### Technical changes to the exhaust manifold, new EGR pipe and heat shield ?

**Vehicle:** T6 2.0 tdi biturbo

**BTS reference:** T913494

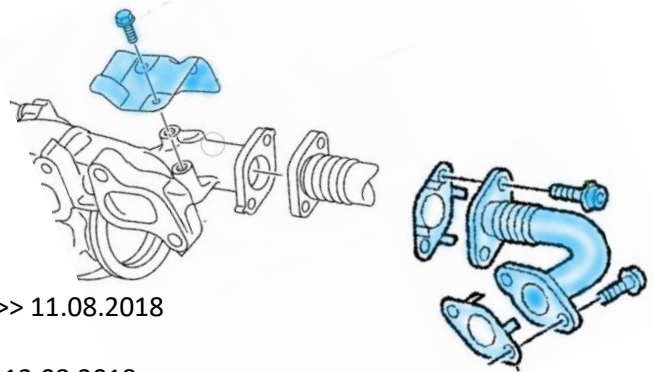
if the old version marked in red has to be replaced, the vehicle manufacturer requires the following components:

2x	106 884 02	screw M6x8
1x	03N 145 811 B	heatshield
2x	03L 131 547 P	gasket
2x	N 910 461 01	screw M8x22
2x	N 910 268 02	screw M8x20

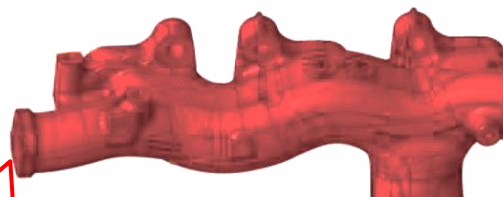
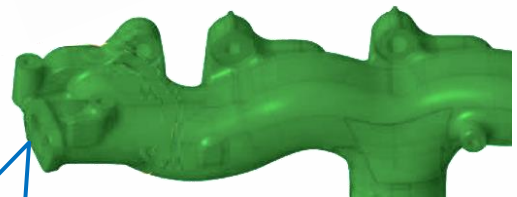
1x	04L 131 521 AK	EGR connecting pipe >> 11.08.2018
or		
1x	04L 131 521 BF	EGR-connecting pipe 12.08.2018 >>

old design  
03N 145 701 >> K  
03N 145 703 >> M  
1000 xxx >> 0273

new design  
03N 145 701 L >>  
03N 145 703 N >>  
03N 145 704 alle  
1000 xxx 0286 >>
